CERTIFICATE OF APPROPRIATENESS

Property: 1121 Walker Street, Tracts 1, 2, 3A & 16, Block 94, SSBB Subdivision. The property includes a historic 206,144 square foot, one-story office building situated on a 10,024 square foot corner lot.

Proposal: Alteration – Replace existing storefronts on the sides facing Walker Street and San Jacinto Street.

SOUTH ELEVATION STOREFRONT DETAIL

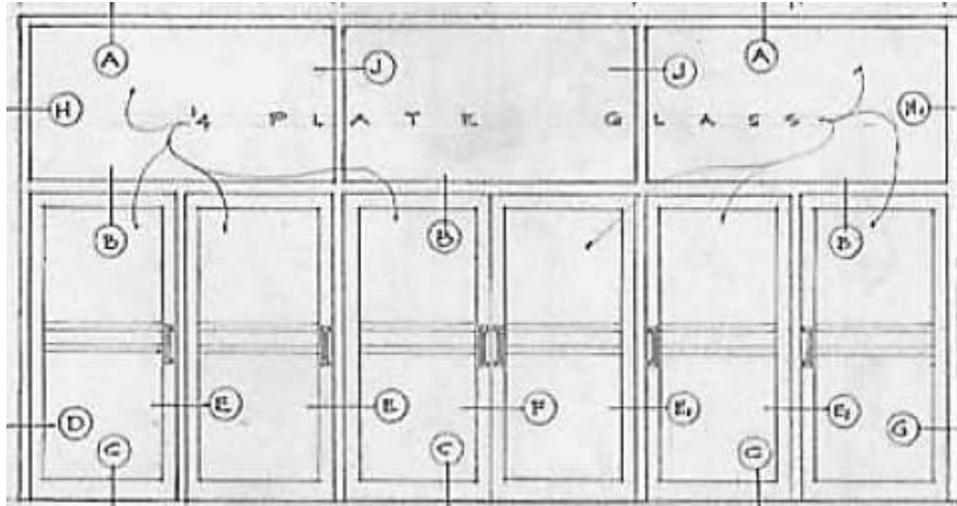
All existing non-original storefronts will be removed and a new aluminum storefront will be inserted into the existing openings. The vertical storefront divisions will mimic the historic composition and align with the window frames above. The aluminum base course will be removed and replaced with granite as shown on the historic drawings.

SOUTH ELEVATION ENTRY DETAIL

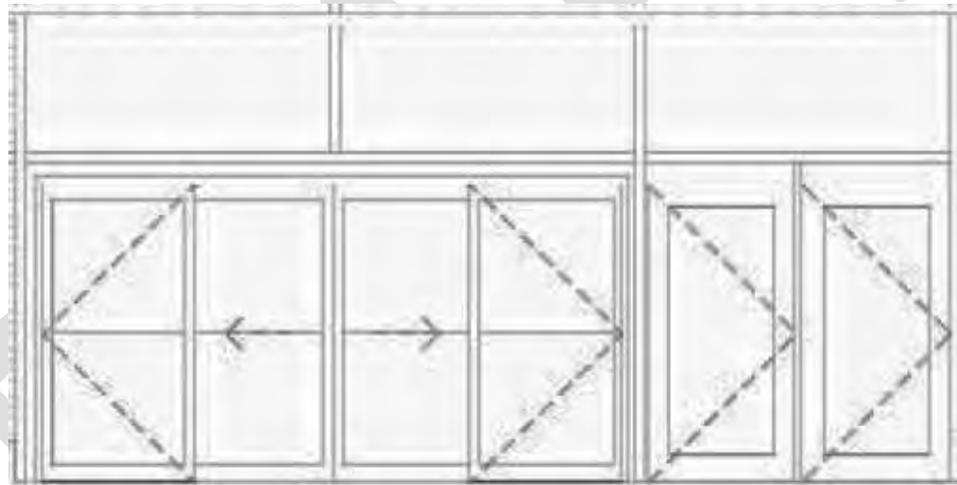
The proposed main entry will replicate the original composition of glass storefront with transoms. A new 14-foot automatic sliding glass door will be situated on the western most side of the existing opening with two single swing doors to the east.

EAST SIDE ELEVATION – FACING SAN JACINTO STREET

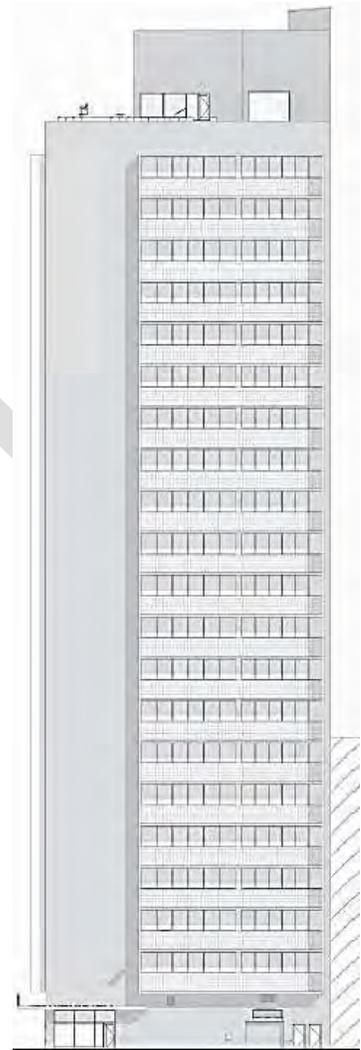
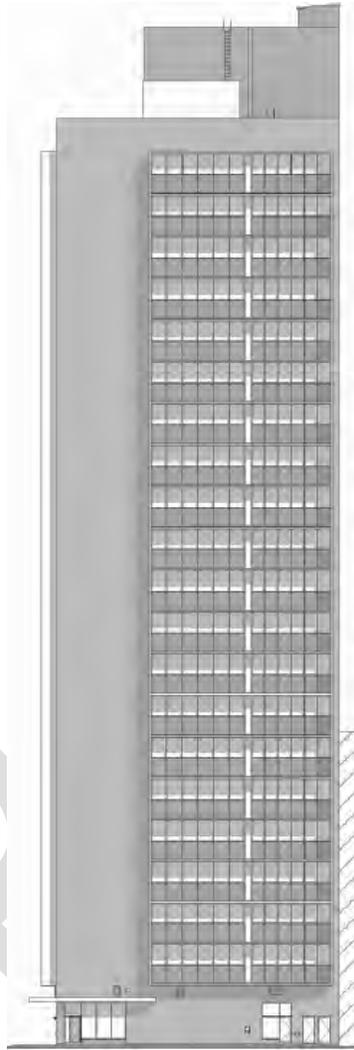
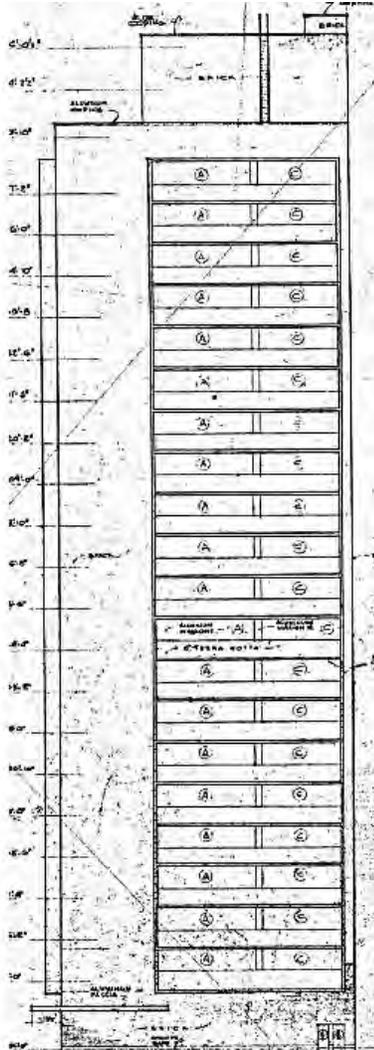
Side Elevation: Two existing storefronts are not original to the building. The south storefront will be removed and (East) replaced. The proposed storefront will be three bays wide with three transoms above and framed with brushed clear anodized aluminum. A door will be installed in the north-most bay. The north storefront will be removed and replaced with an overhead metal door for use as a loading dock. Two existing door openings will be retained and the doors will be removed and replaced with metal frame doors.

NORTH (REAR) ELEVATION

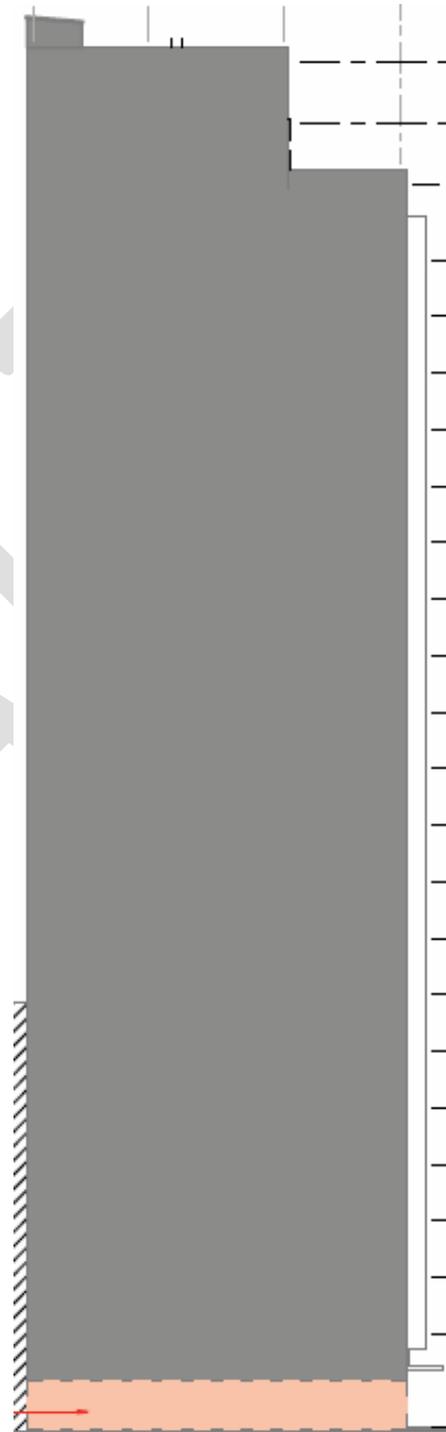
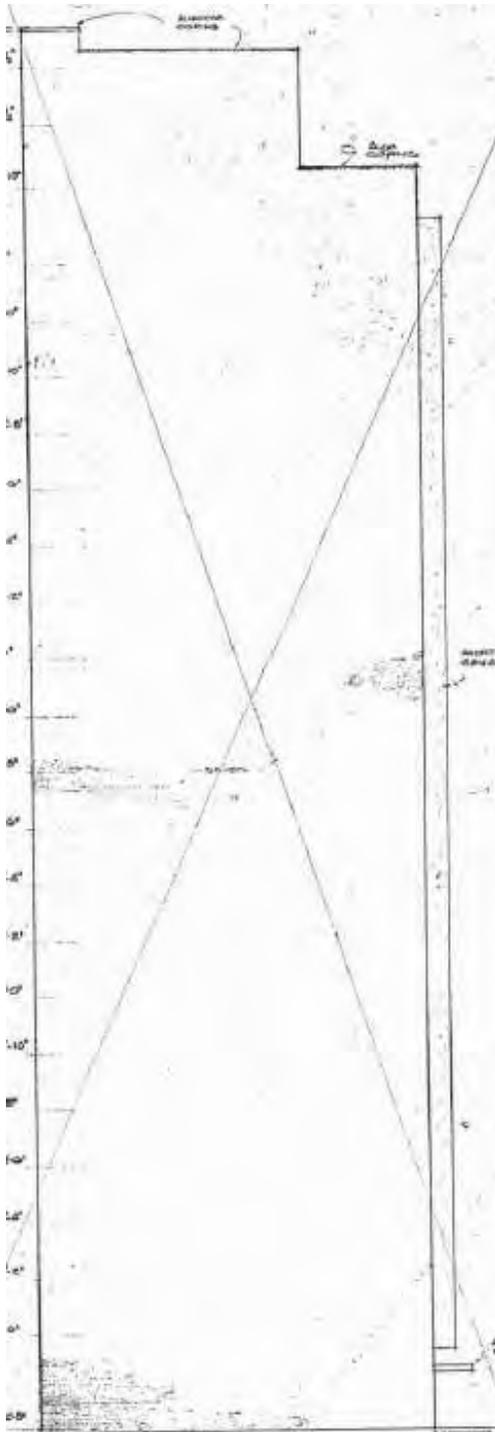
Rear Elevation: An existing metal fire stair is in poor condition and will be removed. See elevation drawings for (North) details.
